STAFF RECOMMENDATION

NCPC File No. 6265

LINCOLN MEMORIAL LINCOLN MEMORIAL CIRCLE SECURITY IMPROVEMENTS, EAST SIDE – BARRIER LOCATION AND DESIGN WASHINGTON, DC

Submission by the National Park Service

Site Plan

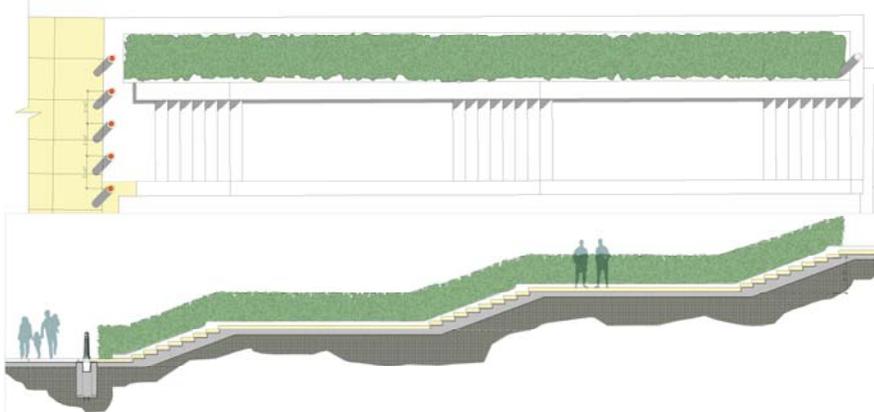
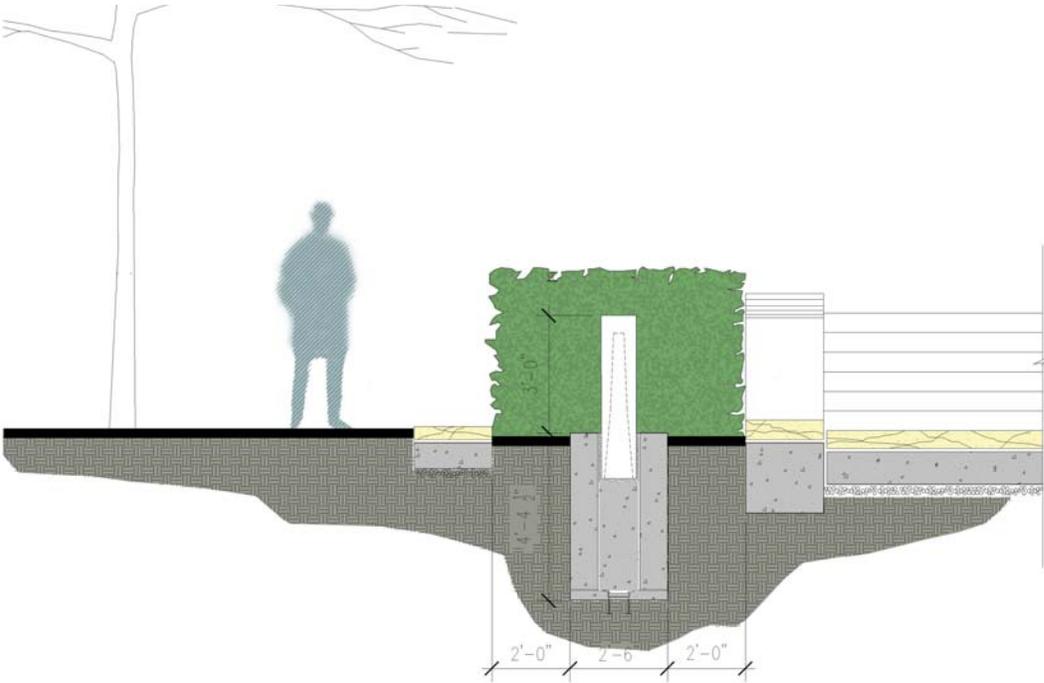
Recommends that the National Park Service develop an unfluted bollard sleeve through further consultation and design study.

The staff agrees with the D.C. State Historic Preservation Office (see the Section 106 discussion below on page 7) that the location of the bollard line is closer to the base of the stairs than desirable. The Commission of Fine Arts, at its July meeting, endorsed the staggered bollard line at the base of the stairs, which increases the distance between the bollards and the base of the stairs at the center section only. CFA has been consistent in stating the desirability of a generous distance between the base of stairs and any barrier line at the Lincoln Memorial. However, staff and other agency staffs reviewed alternatives to the proposed bollard line in the field in July with National Park Service staff without developing a better alternative.

- a prototype of a bollard sleeve design, painted the proposed color
- a prototype of a painted bollard core, together with a sample of the holly hedge at its full height.
- A prototype of a hydraulic bollard proposed for the roadway near Bacon and French Drives.
